## *City of El Paso – City Plan Commission Staff Report*

**Case No:** SUSU12-00057 El Paso Community College Transmountain Campus  
**Application Type:** Resubdivision Combination  
**CPC Hearing Date:** June 28, 2012

# ATTACHMENT 3

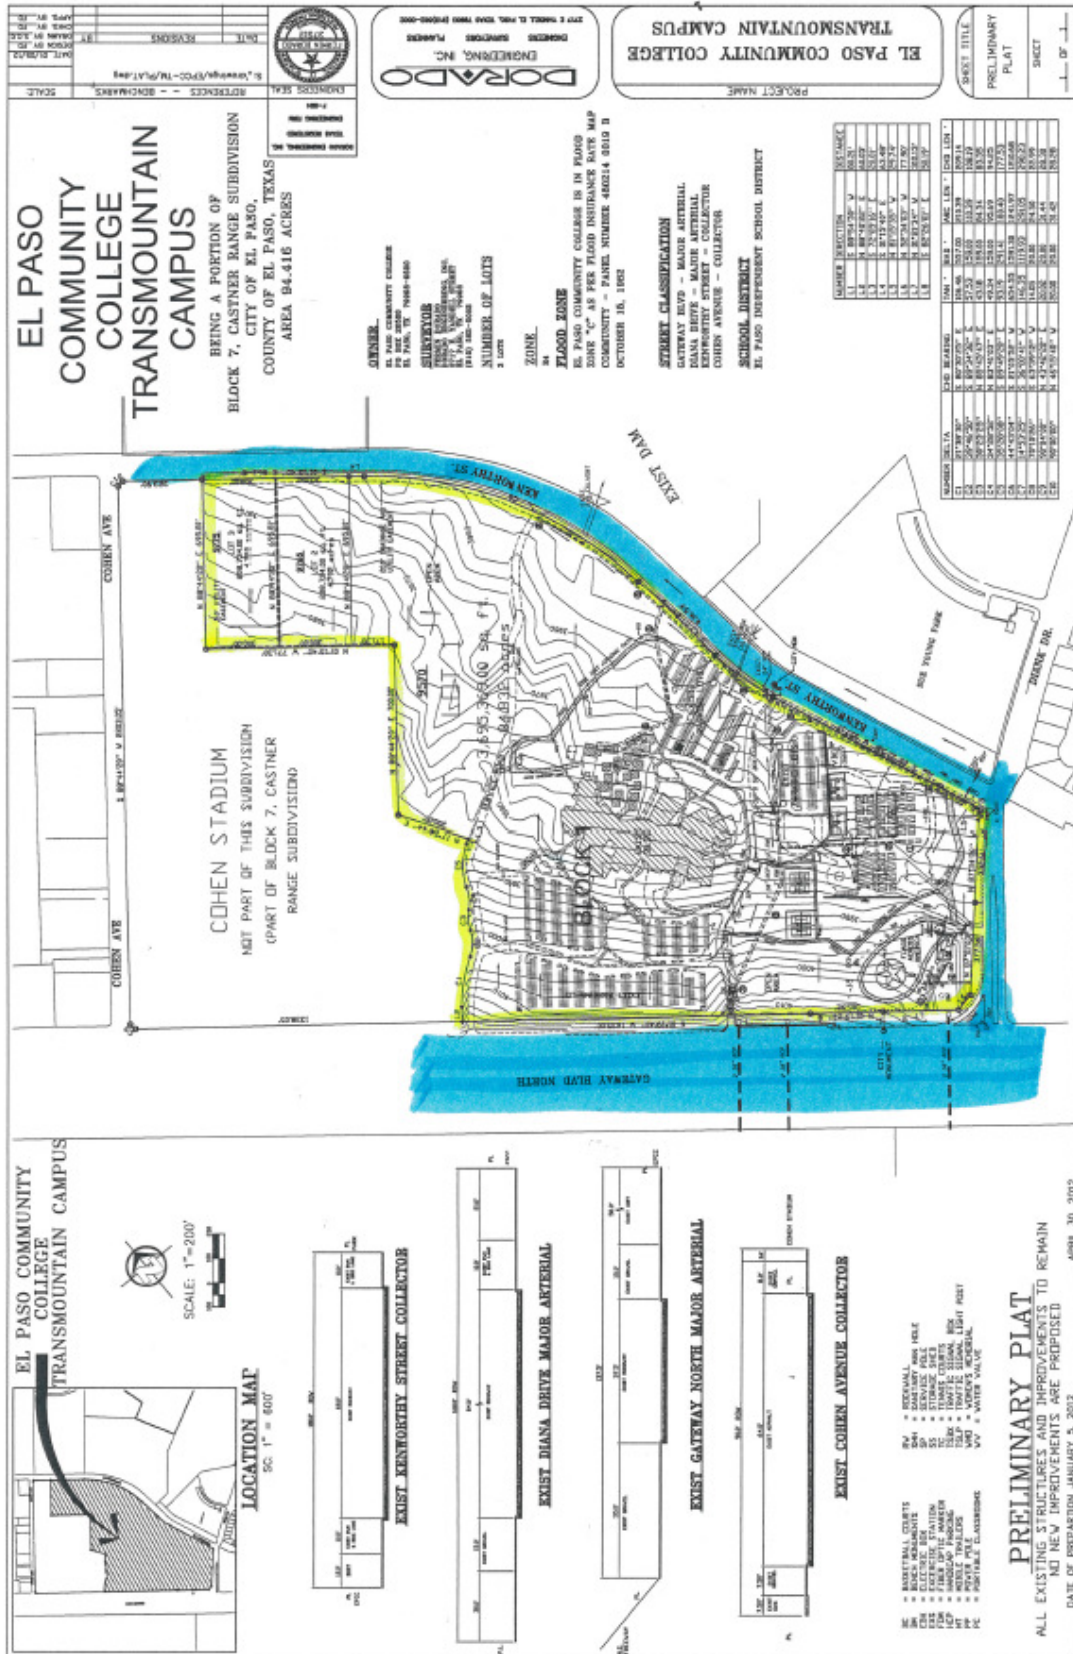
- Label on preliminary plat whether buildings are to remain or be removed.
  - Add the street name (Gateway Blvd North) to the EPCC Campus lot address to better clarify its frontage.

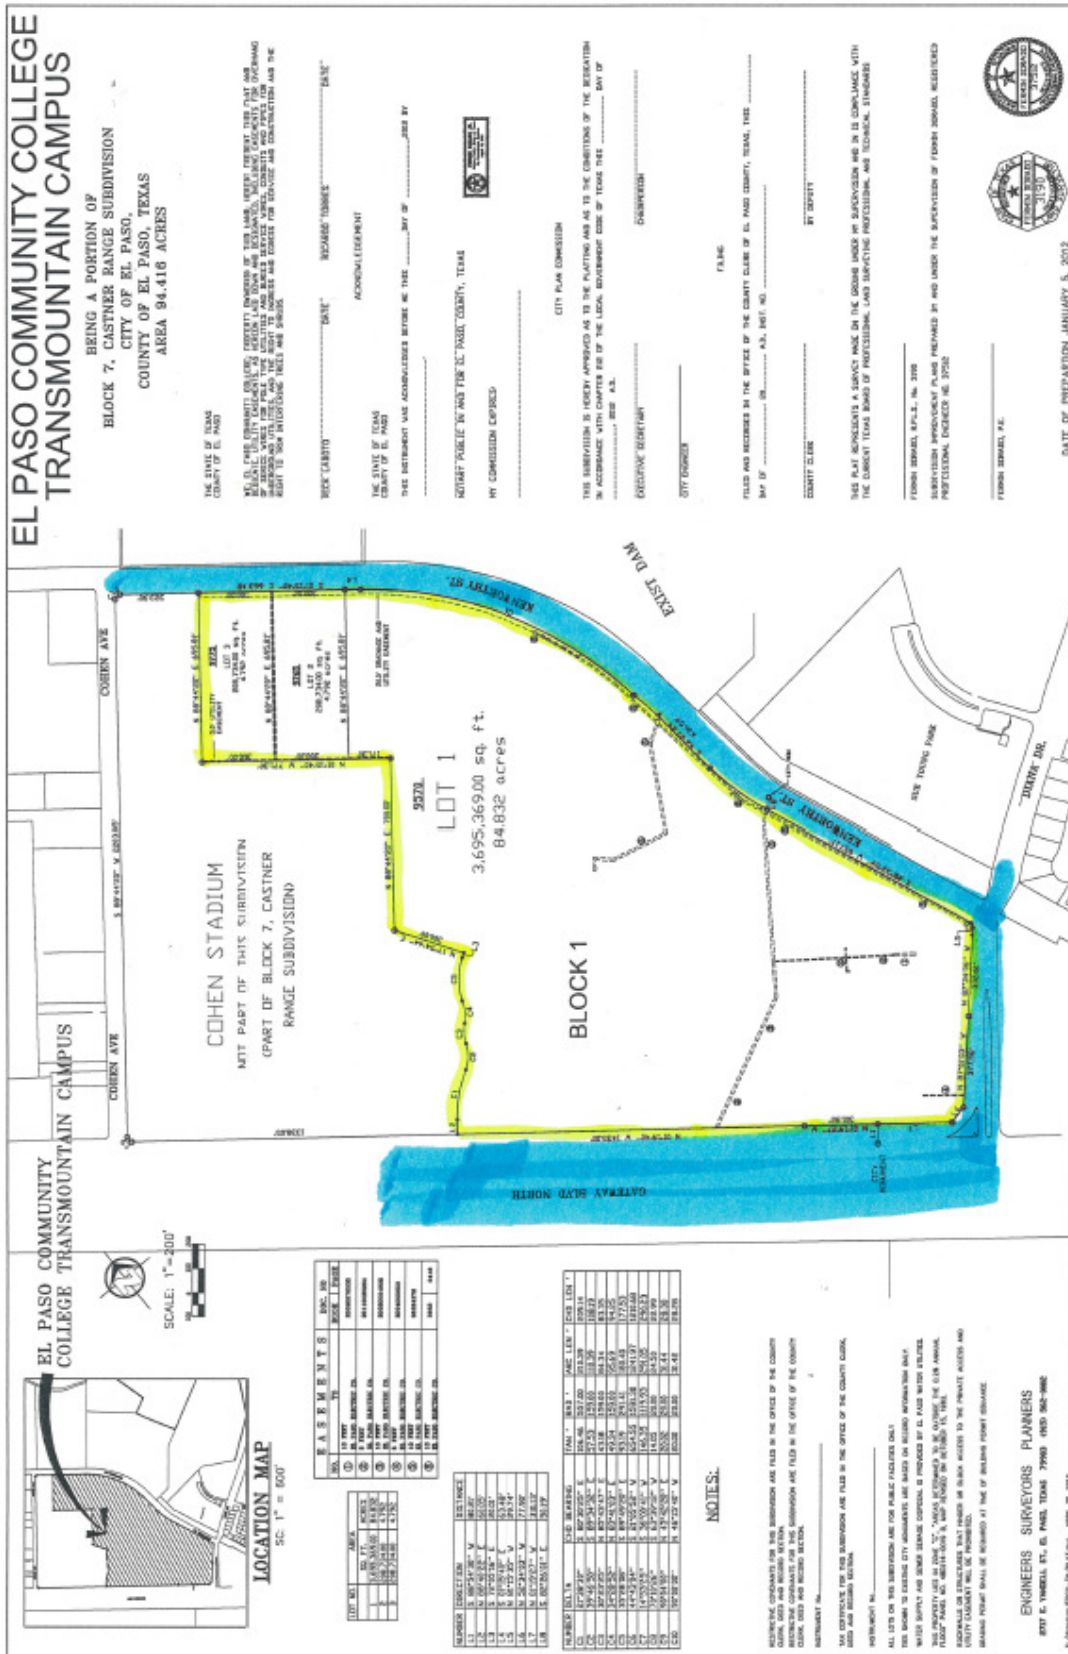
4. Clarify if the proposed drainage easement will be privately maintained. The dedication statement on the final plat does not specifically reference the drainage easement.

3. Applicant shall address the following comments prior to recordation:
  - Provide a note stating the reason for the replat on the final plat.
  - Remove duplicate restrictive covenant sentence on the final plat.

- Change the City Engineer signature line for the CPC approval block to read City Development Director.
  - Add a line for the date to the restrictive covenants and tax certificate notes.

- Label the proposed drainage easement (located along Kenworthy Drive) as private.
  - Include a statement in the final plat notes that indicates that postal delivery service within the subdivision will be provided using neighborhood delivery and collection box units.

*(Drainage easement will be dedicated as a private easement)*

**EXIST DIANA DRIVE MAJOR ARTERIAL**

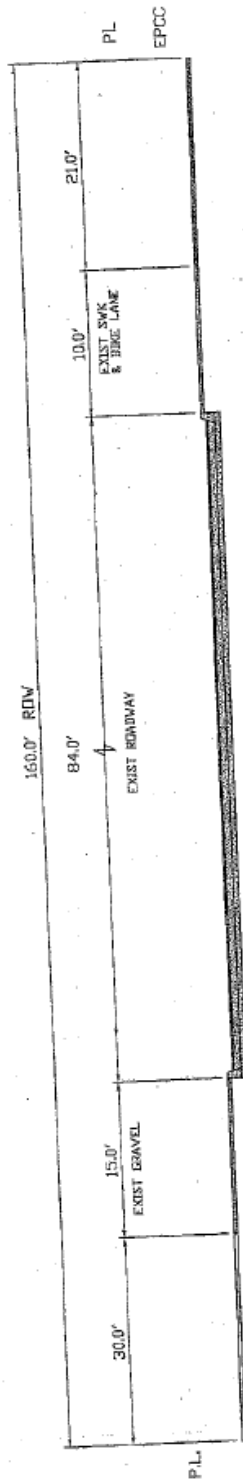
The right-of-way improvements abutting the property to the east and south (Diana Drive and Kenworthy Street) are not in compliance with the current subdivision code. Diana Drive is an existing Major Arterial with 160-ft of right-of-way, including 84-ft of pavement and a 10-ft sidewalk abutting the subject property. The subdivision code requires 110-ft of right-of-way, to include 66-ft of pavement, a 14-ft raised median and 10-ft hike & bike trails and 5-ft parkways on each side. Kenworthy Drive is an existing Minor Arterial with 100-ft of right-of-way, including 68-ft of pavement and 10-ft sidewalks abutting each side. The subdivision code requires 88-ft of right-of-way, to include 44-ft of pavement, a 14-ft raised median and 10-ft hike & bike trails and 5-ft parkways on each side. Per Section 19.10.050(A)1 of the subdivision code, the City Plan Commission may waive the requirement to dedicate and improve the substandard rights-of-way if any of the following factors are met:

***Approval with exception and waiver.*** In this case, the exception may be granted due to the existence and creation of lots greater than one-half acre in size. The right-of-way waiver may be granted due to more than fifty percent (50%) of the lots within a quarter mile of the subject property being developed; and the existing rights-of-way are both in character with the surrounding neighborhood and operate at sufficient capacity.

**EXIST KENWORTHY STREET COLLECTOR**

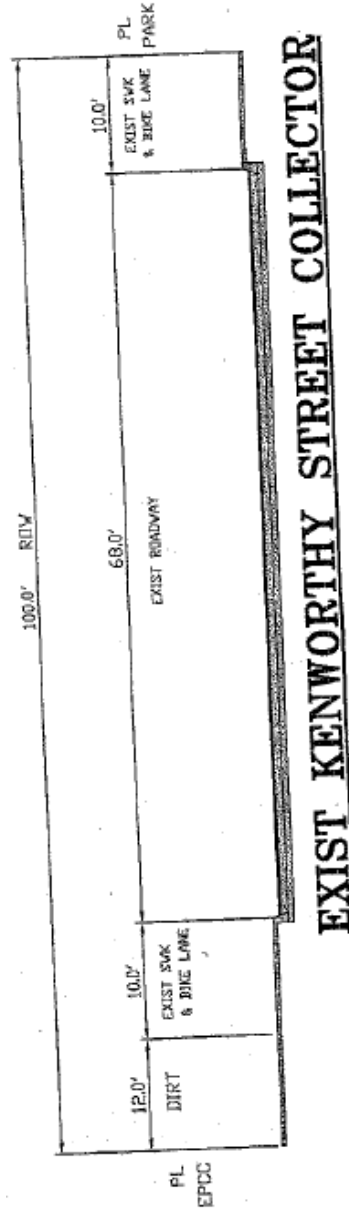
Per Section 19.15.080(A) of the subdivision code, the maximum length of an arterial street shall not exceed one thousand six hundred (1,600) feet. Kenworthy Street exceeds this maximum. However, this section also permits exceptions if certain criteria are met. In this case, an

exception can be allowed for the street to exceed 1,600 foot maximum due to the subject parcels being greater than one-half of an acre in size.
